Pre-Failure Images

**Previous inspection report photographs
(all from cited DWR inspection reports)**

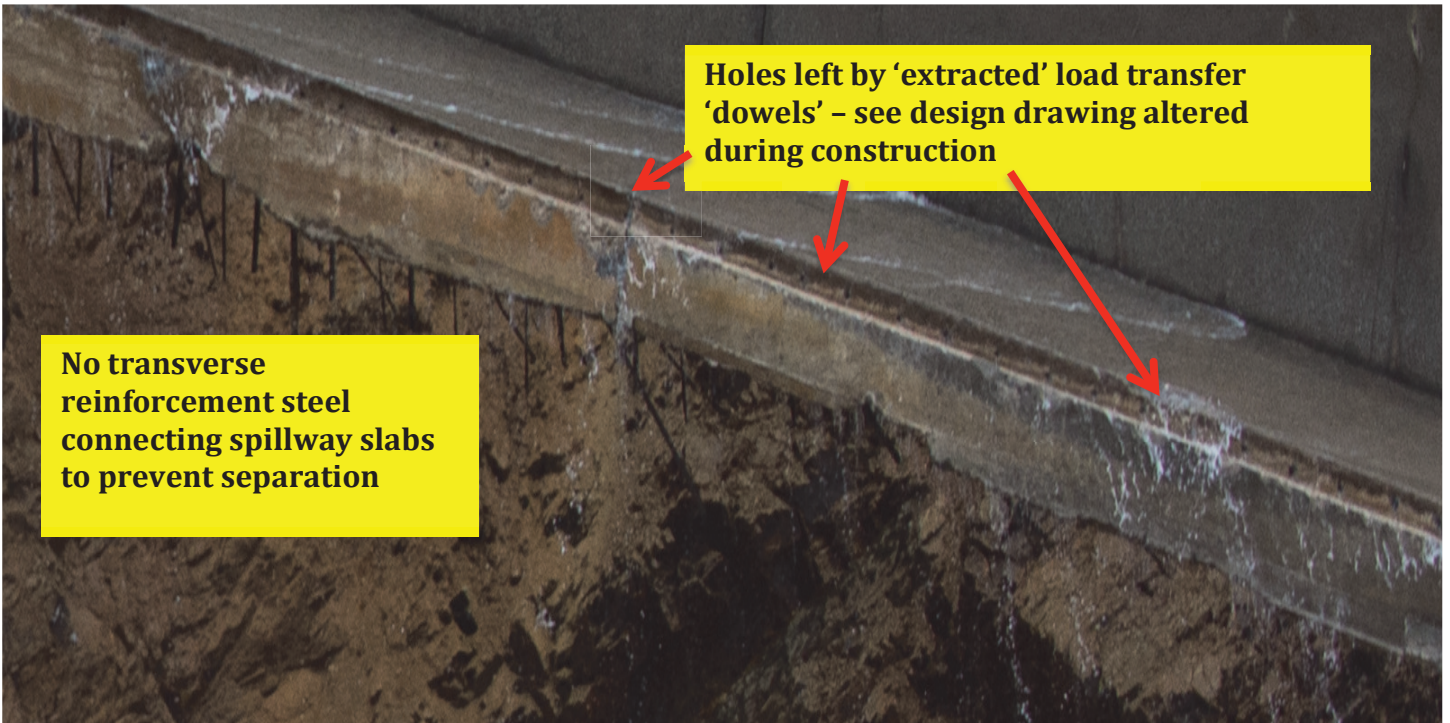
**No transverse
reinforcement steel
connecting spillway slabs
to prevent separation**

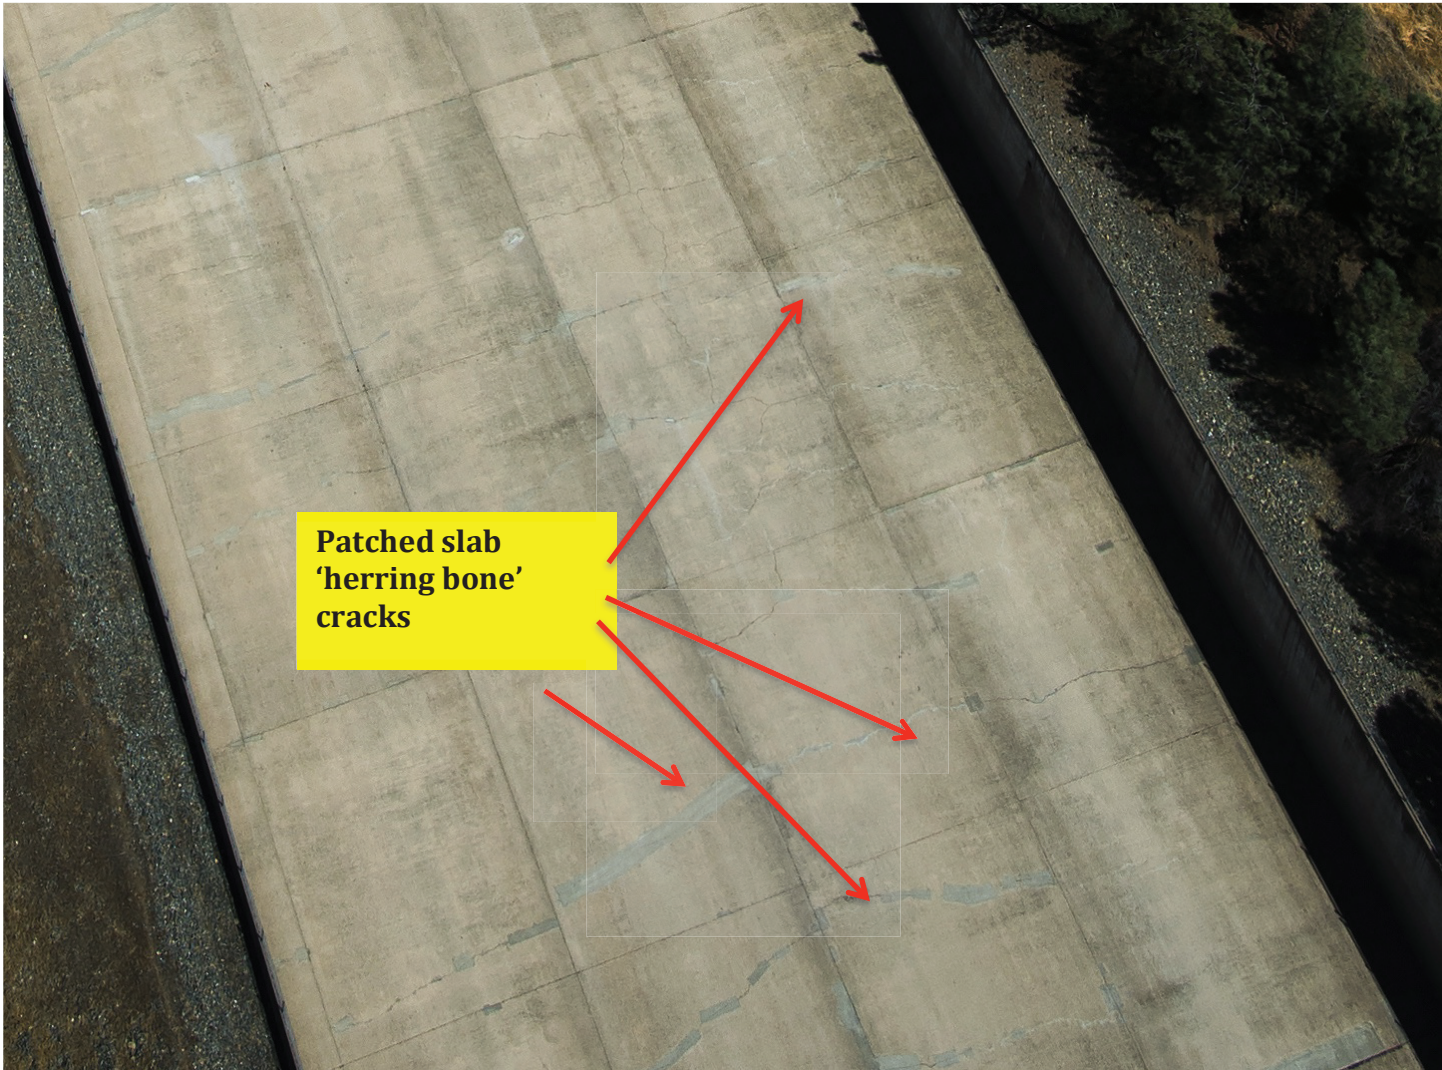
Large trees growing adjacent to spillway wall - roots able to penetrate drains

2/5/13 Inspection Report

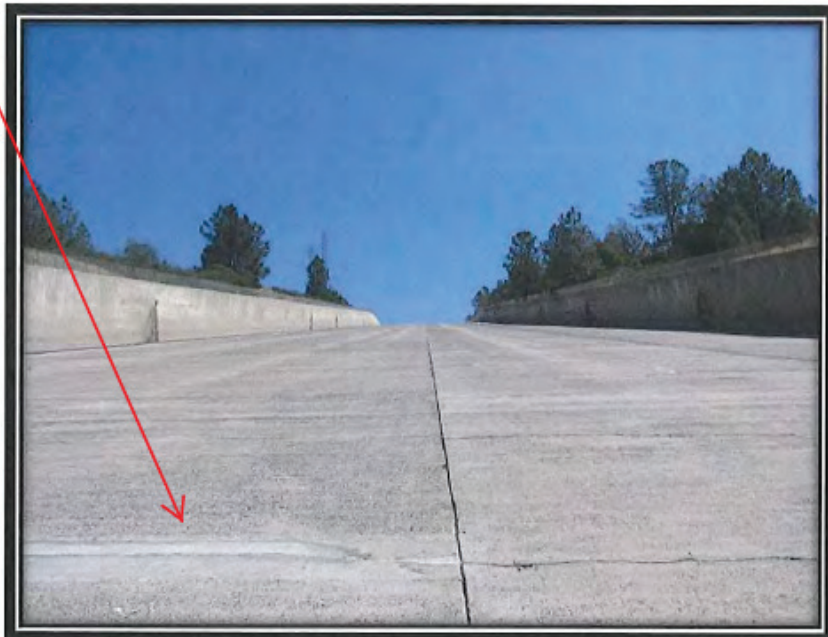
14. The flood control outlet gate seal leakage and drain flow are visible. The trees and brush shown within the ovals should be removed by November 1, 2013. Oroville Dam, No. 1-48

2/3/15 inspection report

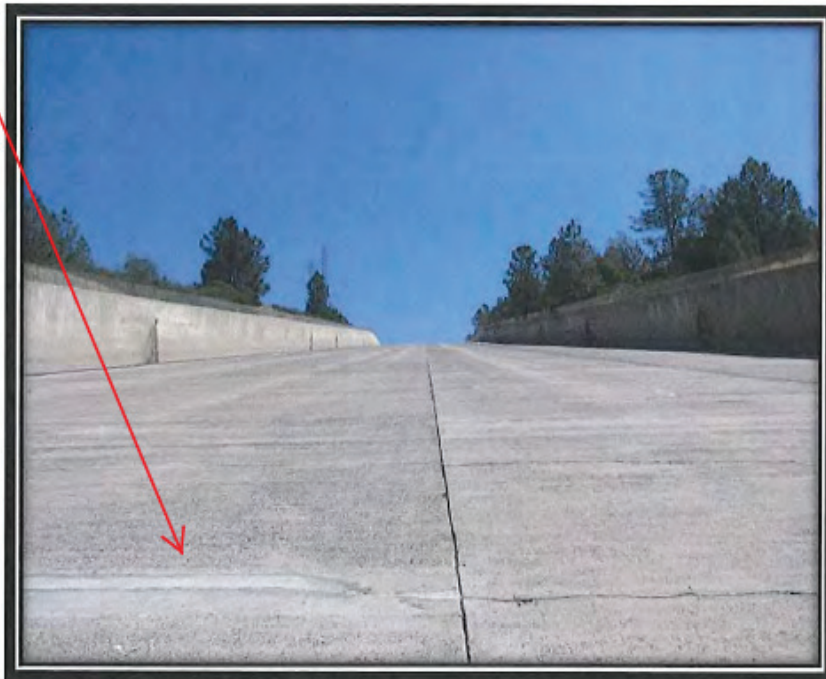
9. This view looking upstream along the FCO discharge chute shows one tree (arrow) that needs to be removed following a significant effort to remove brush along the outside of the wall.
